Straw Polls – Mixing Segment

G. ZIMMERMAN, CME CONSULTING

3/14/2023

Possible Spec – Trunk Connection Interface

168.7.2a Trunk Connection Interface

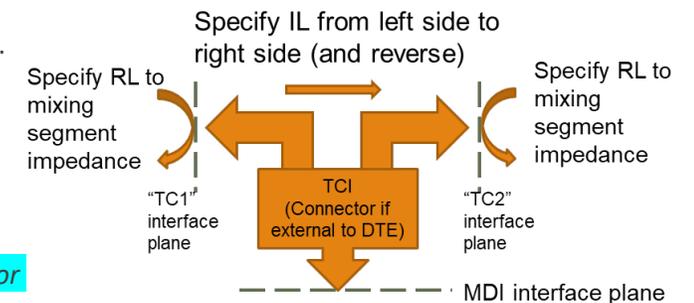
Without a PMA or PMA loading present, the differential insertion loss of the TCI between the trunk ports shall be less than **TBD dB (small number)** from 0.3 to 40 MHz, in each direction, measured into 100 ohms.

With the specified PMA or PMA present, the differential insertion loss of the TCI between the trunk ports shall be less than **TBD dB (allows for compensation and phy loading – may be an equation)** from 0.3 to 40 MHz, in each direction, measured into 100 ohms.

Without a PMA or PMA load present at the MDI attachment, the return loss of the TCI at port CP1 and CP2 shall be greater than Equation **169-X** with the other trunk port terminated in 100 ohms. **(NOTE – this is to allow meeting the unloaded trunk RL spec)**

With a PMA or PMA load present at the MDI attachment, the return loss of the TCI at port CP1 and CP2 shall be greater than Equation **169-Y** with the other trunk port terminated in 100 ohms. **NOTE - this specification replaces the MDI return loss and is measured at the TCI.**

The TC adaptor and the MDI may be located within a single assembly, presenting negligible stub length when the MDI is open circuit, and may include compensation engaged when a PMA or PMA load is attached. **(NOTE – should we specify the length of a stub, and if so, how – in cm? In ns delay? – alternatively, as TBD shunt capacitance based on the various studies?)**
